**SECTION 00 91 05  
ADDENDUM NUMBER 5**

**DATE:               SEPTEMBER 7, 2017**

**PROJECT:           ORCHARD VALLEY CLUBHOUSE HVAC RENOVATIONS  
2411 W ILLINOIS AVENUE  
AURORA, ILLINOIS 60506**

**PROJECT NO:       17-253-1110**

#### **4.05 DRAWING E300 - ELECTRICAL FLOOR PLANS**

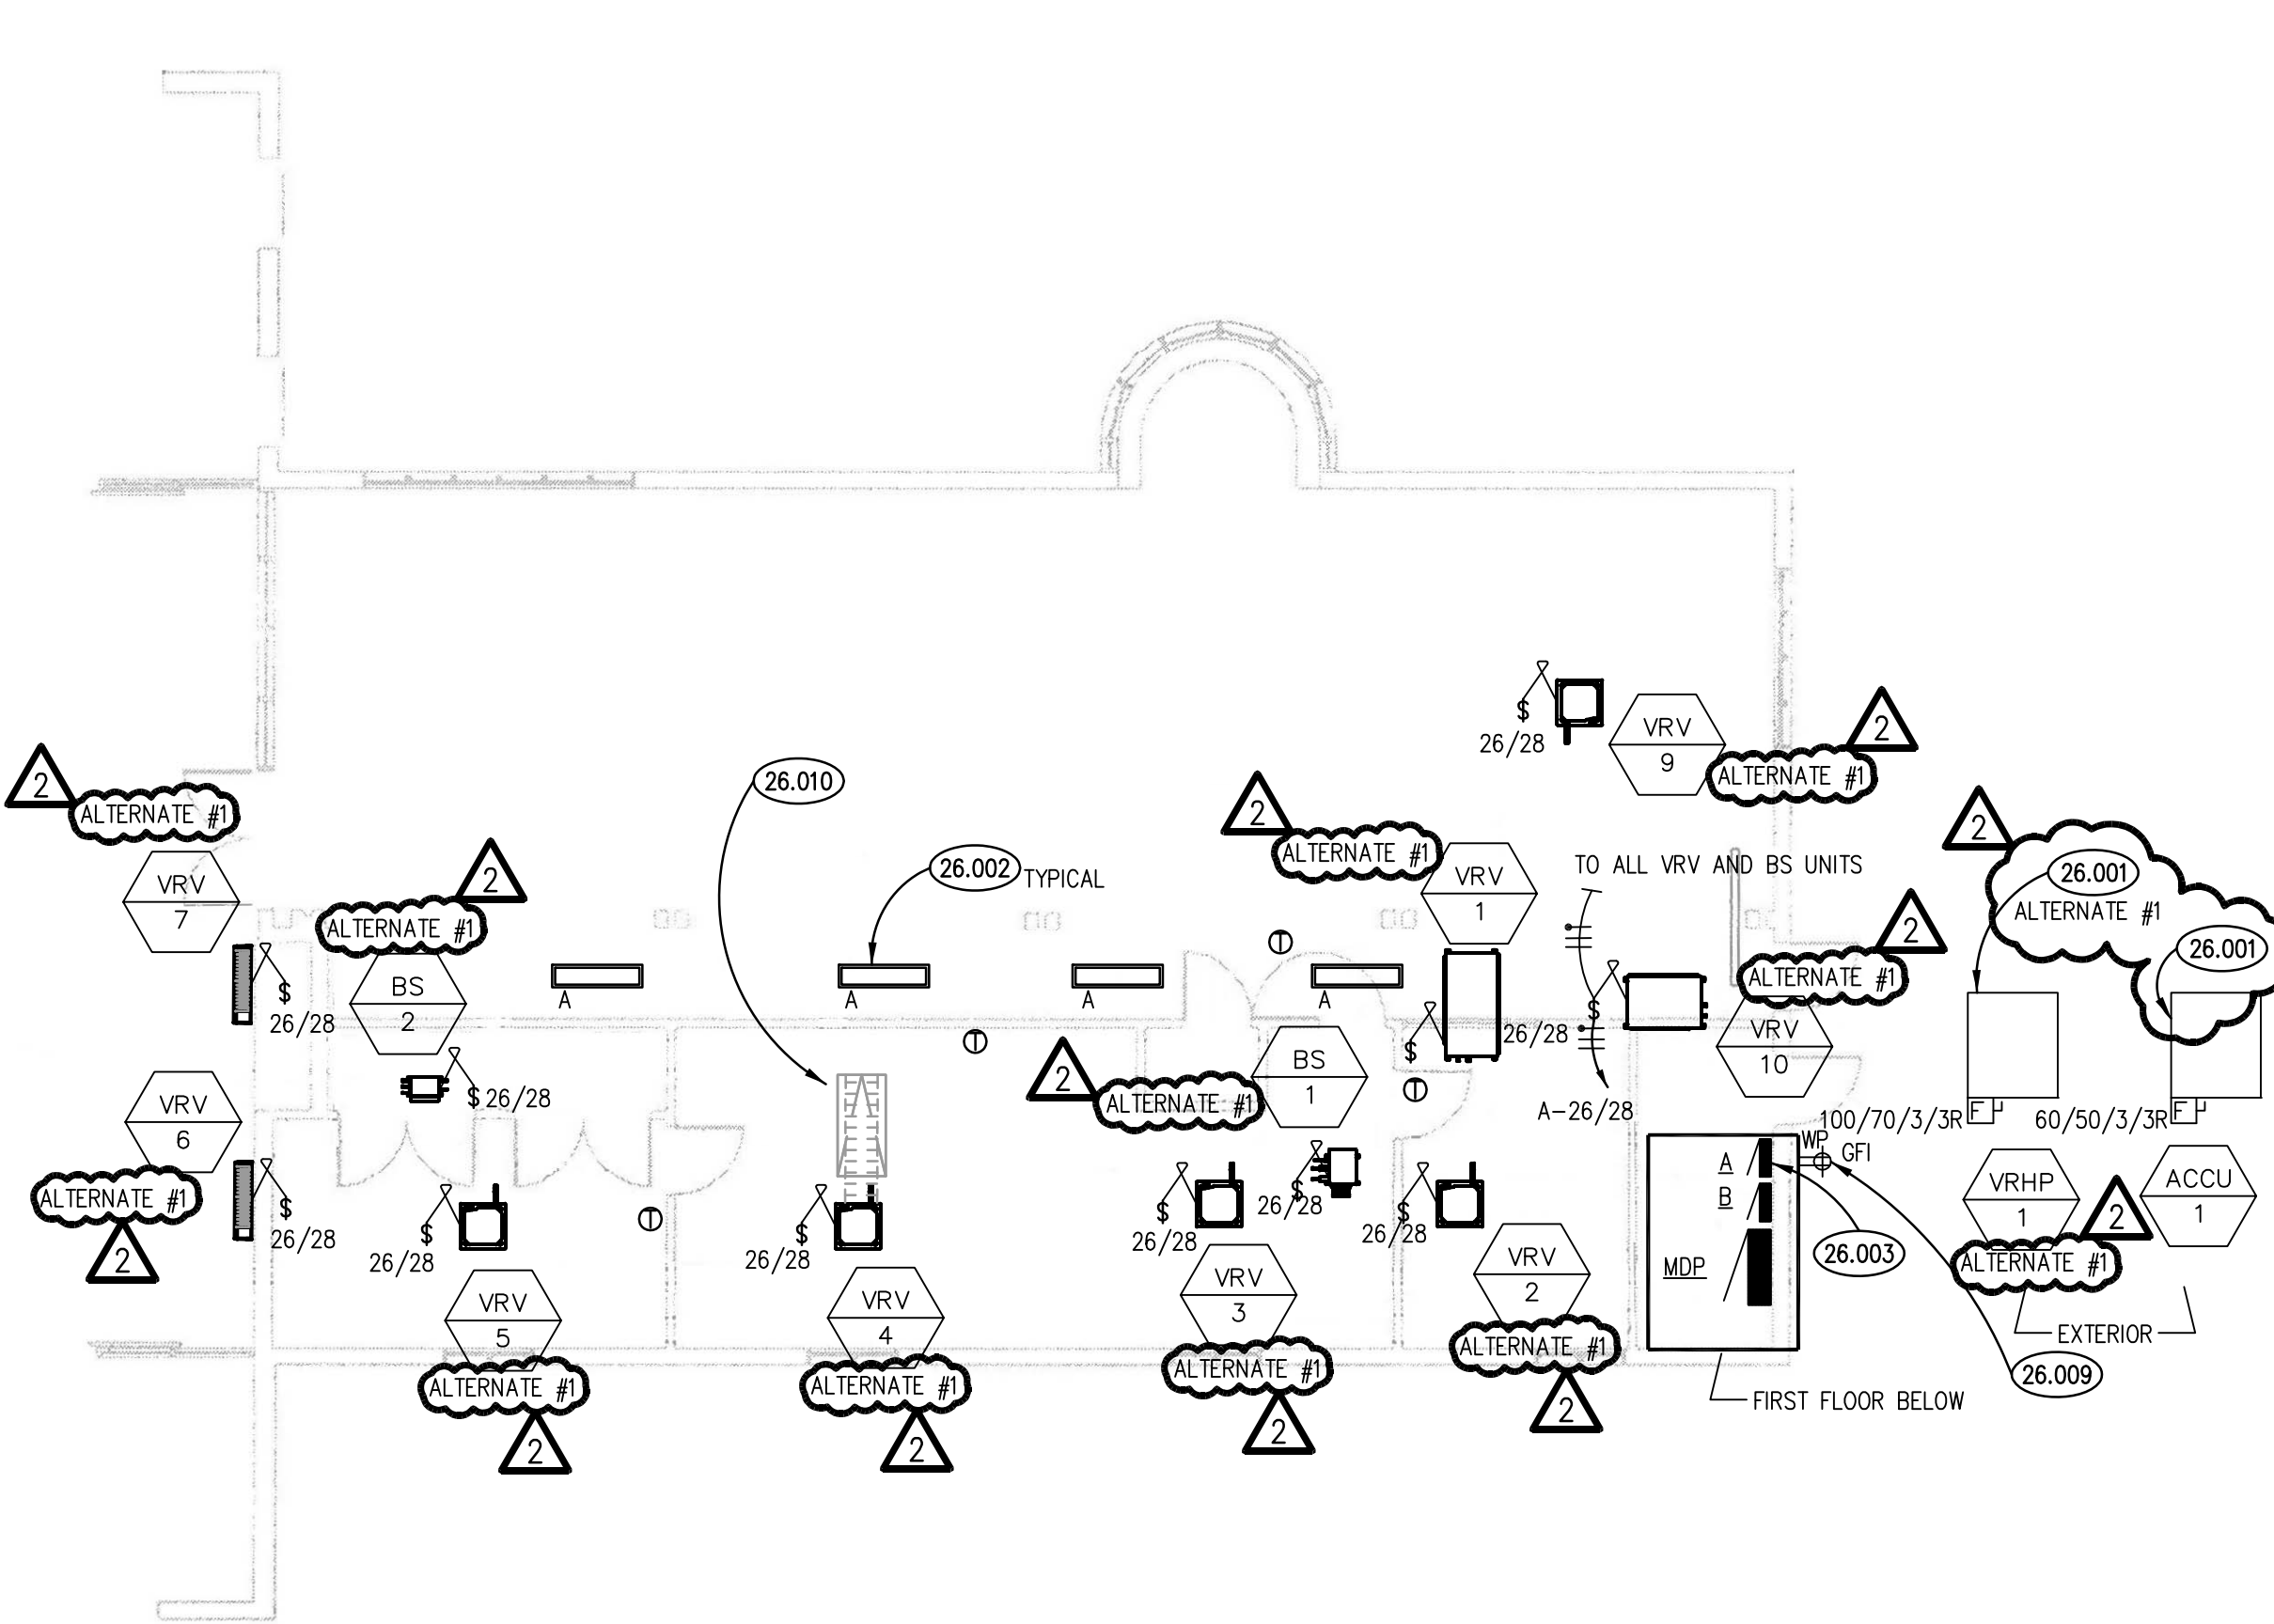
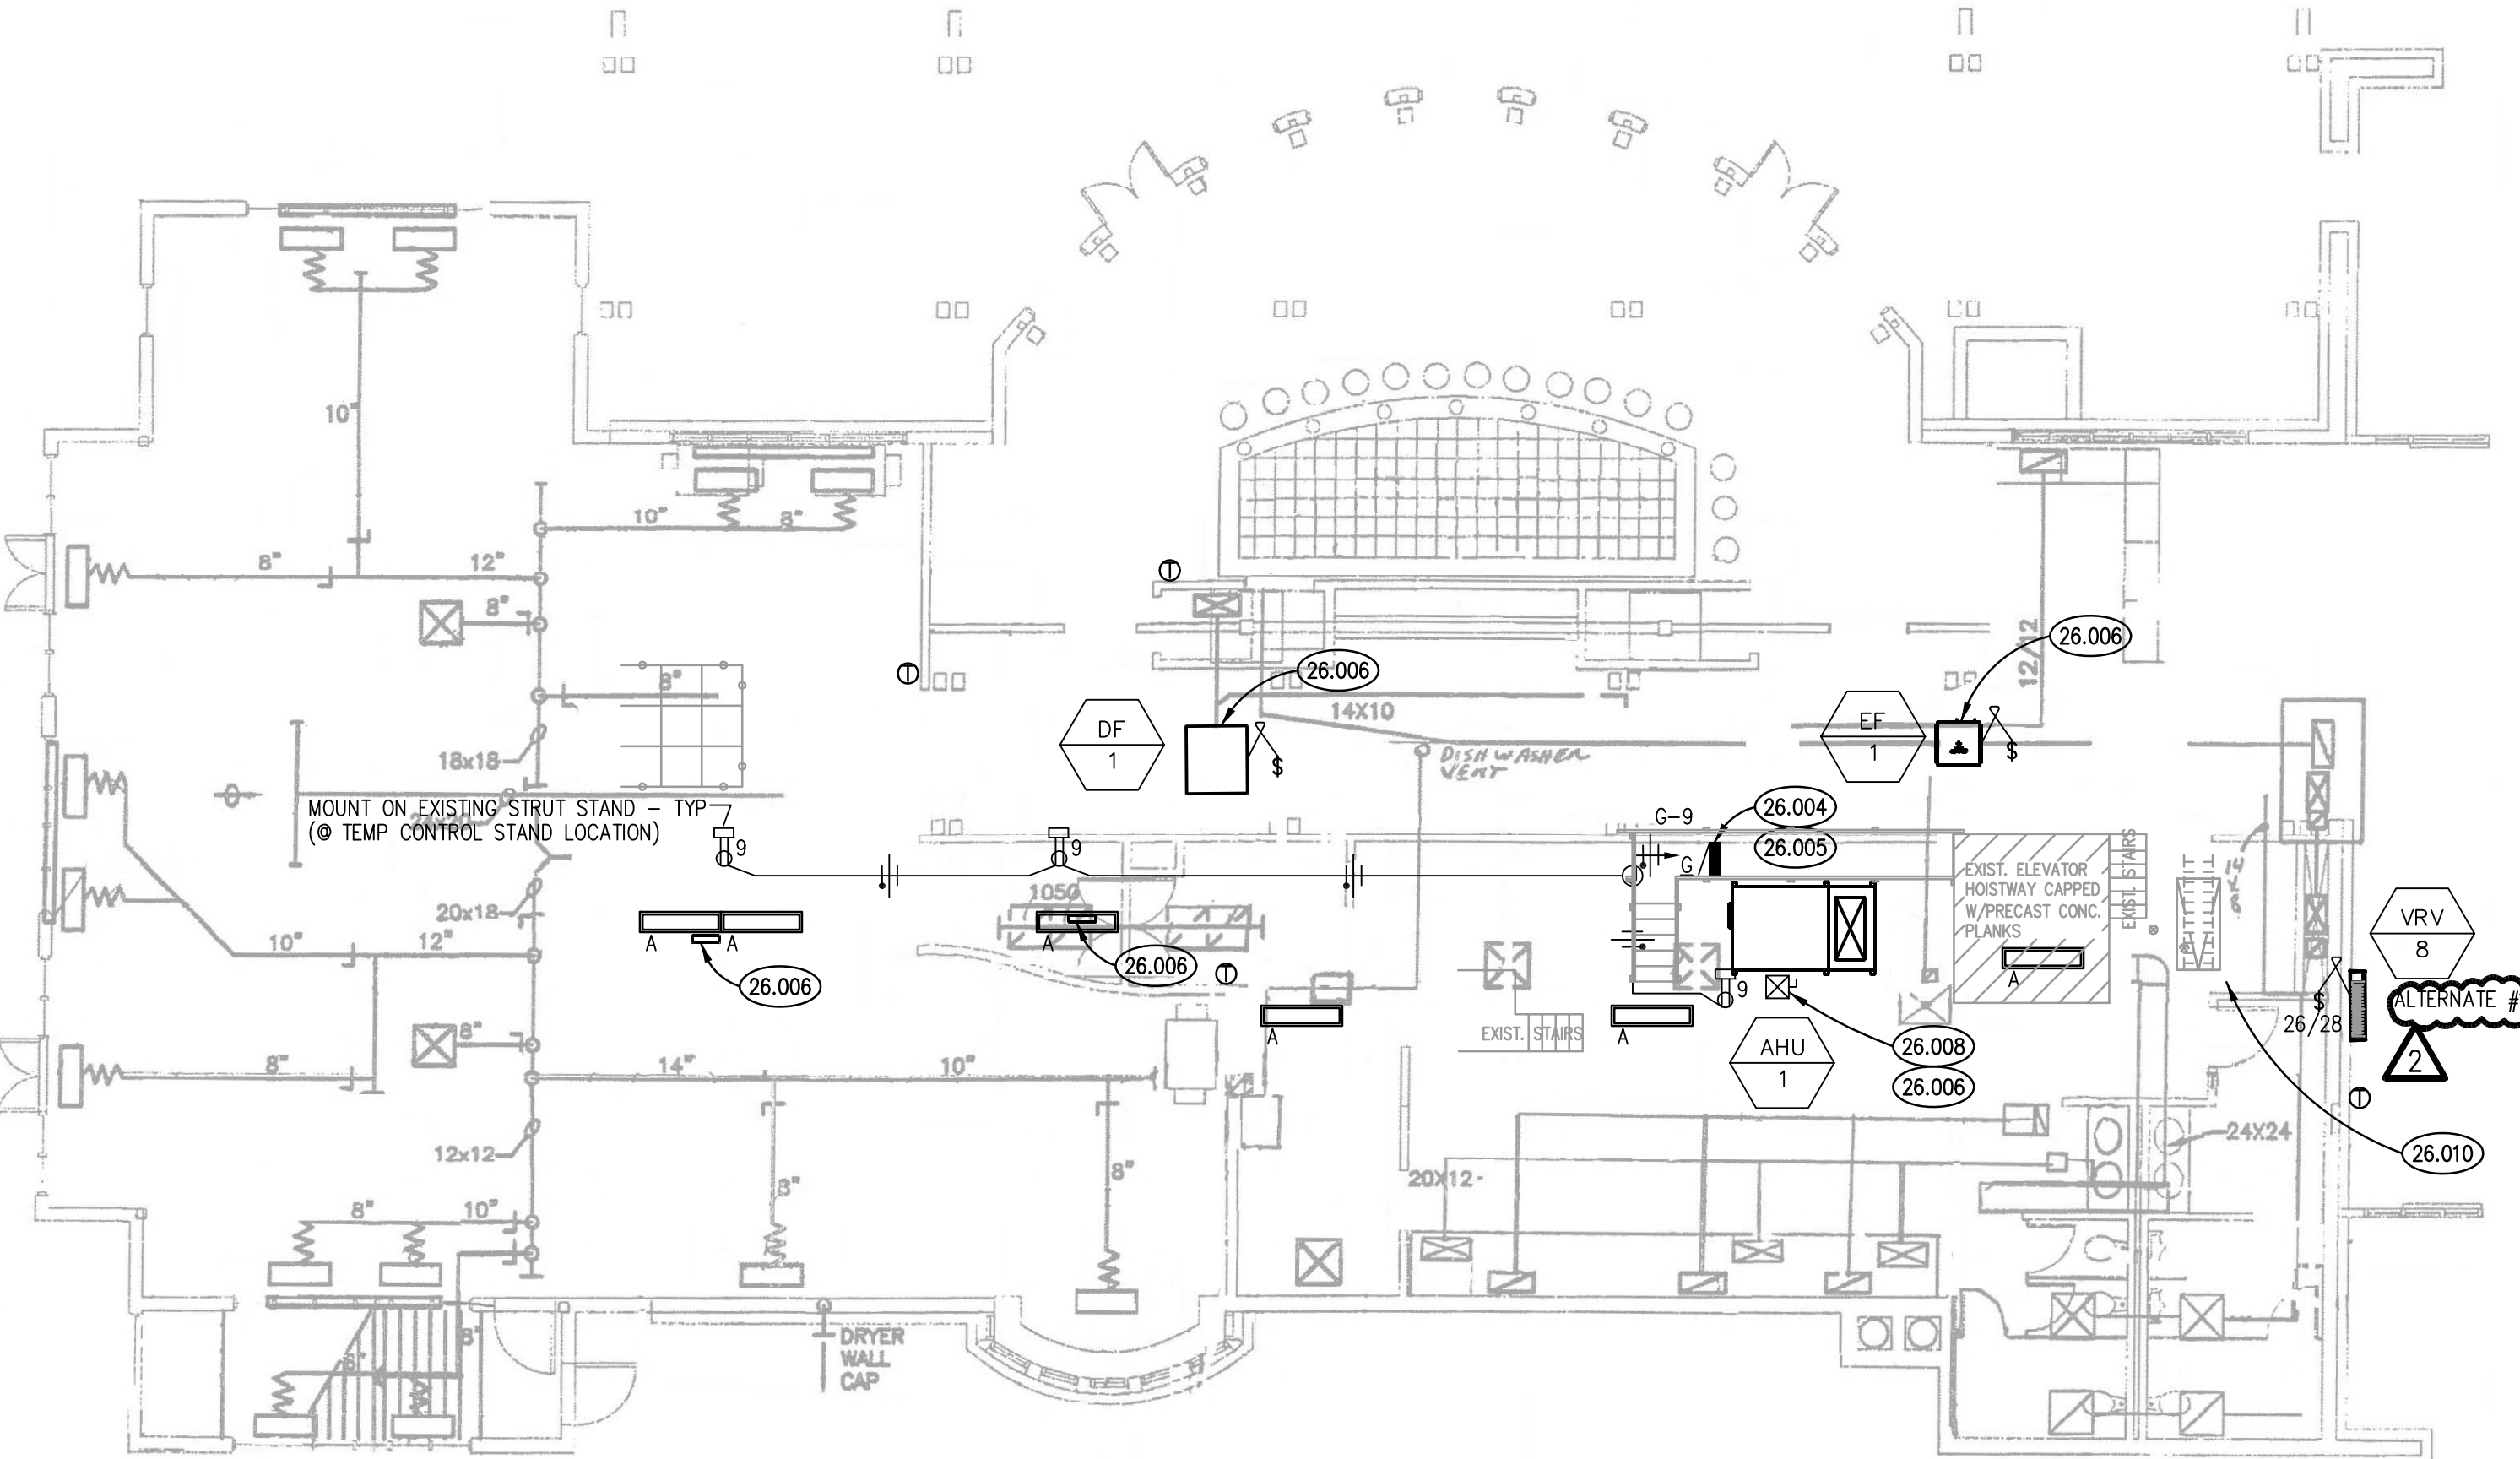
A. Delete this Drawing in its entirety and replace with revised Drawing E300 - ELECTRICAL FLOOR PLANS (attached).
